Item ID: D350-607-041 Accept ***N900040100*** Setup Start ***NS1***
 Revision ID: Stop ***NS2***
 Item Name: AS350/AS355 Heli-Utility-Basket™ Long Version - Fits LH or RH
 Start Date: 5/26/2016 Start Qty: 1.00 ***1*** Cust Item ID:
 Required Date: 6/7/2016 Req'd Qty: 1.00 ***1*** Customer:
 Reference:

DART SERVICE INSTRUCTION

TO AMEND INSTALLATION INSTRUCTIONS D350-607-1 REV. A AND
INSTRUCTIONS FOR CONTINUED AIRWORTHINESS ICA-D350-607 REV. 6

A	NEW ISSUE	MB	14.09.25
REV.	DESCRIPTION	BY	DATE
DESIGN		DART AEROSPACE LTD	
DRAWN		HAWKESBURY, ONTARIO, CANADA	
CHECKED		DRAWING NO.	REV. A
MFG. APPR.	N/A	DSI 9709	SHEET 1 OF 4
APPROVED		TITLE	SCALE
DE APPR.		PARTS LIST CORRECTION	NTS
DATE	14.09.25	COPYRIGHT © 2014 BY DART AEROSPACE LTD THIS DOCUMENT IS PRIVATE AND CONFIDENTIAL AND IS SUPPLIED ON THE EXPRESS CONDITION THAT IT IS NOT TO BE USED FOR ANY PURPOSE OR COPIED OR COMMUNICATED TO ANY OTHER PERSON WITHOUT WRITTEN PERMISSION FROM DART AEROSPACE LTD.

**FIGURE 1: CHANGES TO FIGURE 2 OF D350-607-1 REV. A
AND FIGURE 25-1 OF ICA-D350-607 REV. 6**

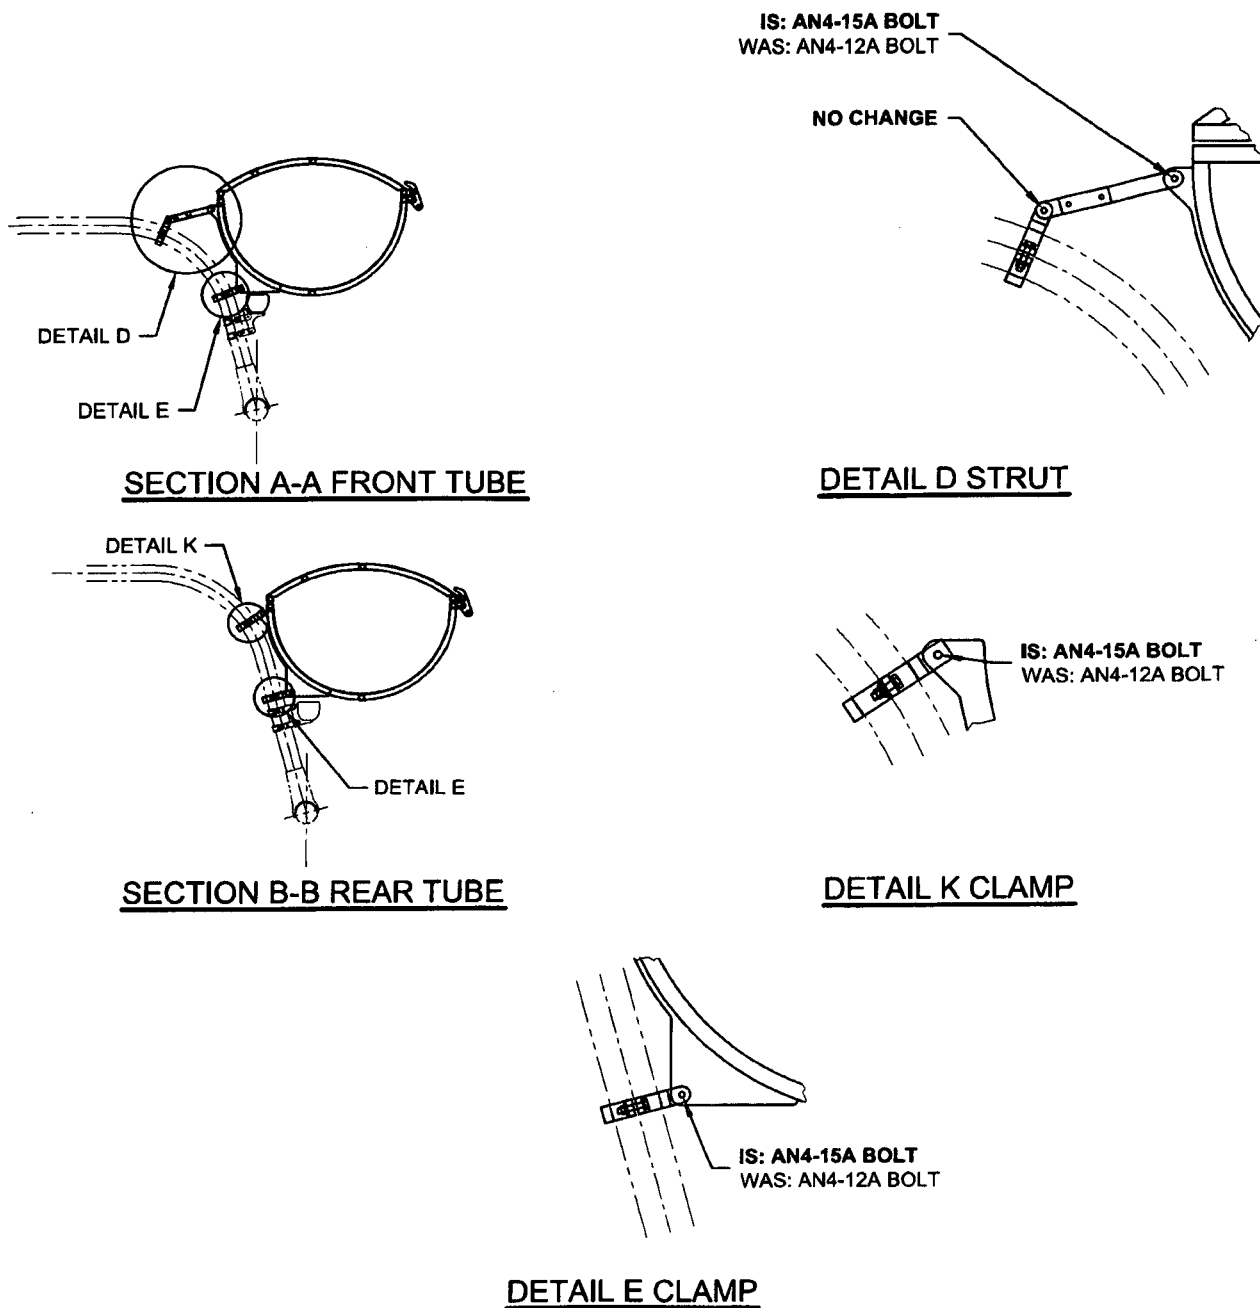
- 2.1 Sheet 2 of this DSI amends Figures 2 of D350-607-1 Rev. A and 25-1 of ICA-D350-607 Rev. 6;
- 2.2 Sheet 3 of this DSI amends Figures 3 of D350-607-1 Rev. A and 25-2 of ICA-D350-607 Rev. 6;
- 2.3 Sheet 4 of this DSI amends the Parts Lists of Installation Instructions D350-607-1 Rev. A (Sections 6.1 and 6.2) and ICA-D350-607 Rev. 6 (Sections 25.27.1 and 25.27.2).

**FIGURE 2: CHANGES TO FIGURE 3 OF D350-607-1 REV. A
AND FIGURE 25-2 OF ICA-D350-607 REV. 6**

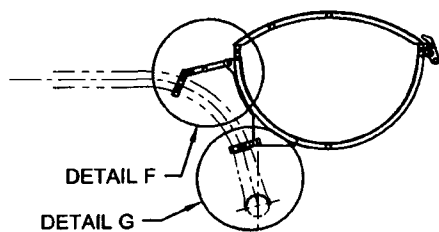
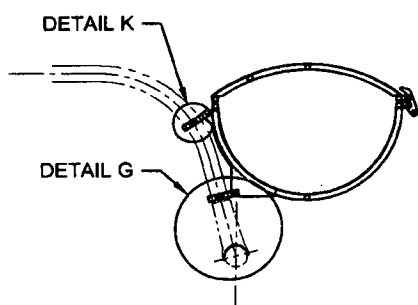
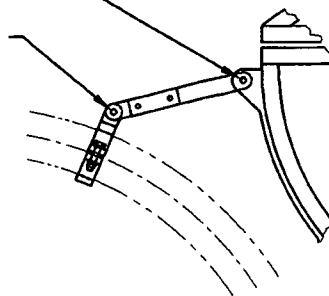
IS: AN4-15A BOLT
WAS: AN4-12A BOLT

IS: AN4-15A BOLT
WAS: AN4-12A BOLT

IS: AN4-15A BOLT
WAS: AN4-12A BOLT
